2024年2月26日  
アドバンテック株式会社

## 産業用サーバマザーボードASMB-585、ASMB-785、ASMB-586、ASMB-786

### DCファン用IC削除、及びBIOS変更のお知らせ

(5) 変更詳細 - 写真

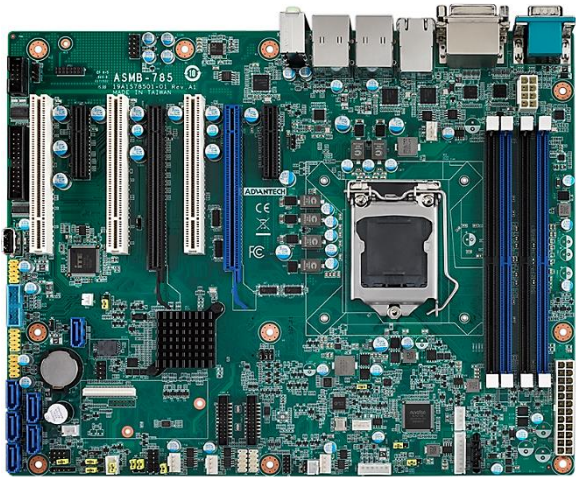
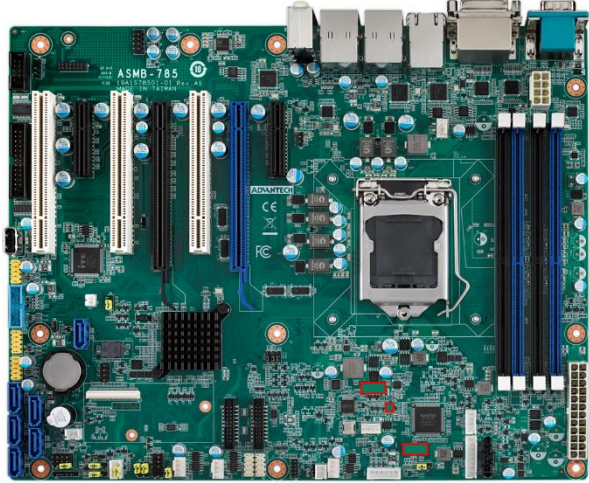
Affected Models	Current Component	New Component	Category	Outlook Difference	Reason
ASMB-585G2-00A1E ASMB-585G4-00A1E	1420056506 (V4.01)	1420059342 (V4.02)	BIOS	N	[for all listed ASMB series] 1. Function improvement 2. Adjust CPU0-TMP sensor threshold 3. Add CVE-2022-40982 INTEL-SA-00828 Downfall security issue solution 4. Mini PWM setting from 20% to 40%
ASMB-785G2-00A1E ASMB-785G4-00A1E	1420056507 (V4.01)	1420059341 (V4.02)	BIOS	N	
ASMB-586G2-00A1 ASMB-586G4-00A1 9691S586P00	1420056510 (V5.00)	1420059340 (V5.01)	BIOS	N	
ASMB-786G2-00A1 ASMB-786G4-00A1	1420056511 (V5.00)	1420059339 (V5.01)	BIOS	N	
ASMB-585G2-00A1E ASMB-585G4-00A1E	1410032340-01 14S2076600	NA	DC Fan switch IC	Y	[ASMB-585/785 only] 5. Support Legacy RAID  DC Fan switch IC has already EOL. Remove DC Fan switch IC and onboard jumper.
ASMB-785G2-00A1E ASMB-785G4-00A1E	1653300100	1653002818	SYSFAN & CPUFAN jumper	Y	
ASMB-586G2-00A1 ASMB-586G4-00A1 9691S586P00

現行品 (DCファンICあり、ジャンパーあり)	後継品 (DCファンIC無し、ジャンパーをワイヤ接続に変更)
ジャンパ		
MB For example
